SERVICE BULLETIN

Classification: EL14-033	Reference: NTB14-106	Date: November 19, 2014
-----------------------------	-------------------------	----------------------------

2013-2014 FRONTIER, XTERRA; INTERMITTENT LOSS OF XM AUDIO RECEPTION AND ALBUM INFORMATION

APPLIED VEHICLES: 2013 – 2014 Frontier (D40)
Built before 5N1AN0NW(*)FN 650002 / Aug 6, 2014
2013 – 2014 Xterra (N50)
Built before 1N6AD0FV(*)FN 700004 / Aug 6, 2014

Figure 1

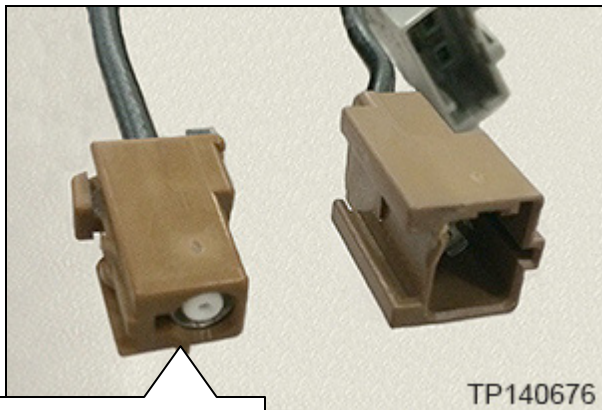
- **Brown** as shown in Figure 1 on page 2, replace the XM antenna and satellite feeder cable with the parts from the Parts Information table.
 - Refer to the Electronic Service Manual (ESM) section **AV – Audio, Visual & Navigation System** for the procedure to replace the XM antenna and satellite feeder cable.

NOTE: The XM antenna and satellite feeder cable can only be replaced as a set.
- **Green** as shown in Figure 2 on page 2 the parts have already been replaced with the High Gain antenna and satellite feeder cable; this bulletin does not apply.
 - Refer to the ESM section **AV – Audio, Visual & Navigation System** for further diagnostics.
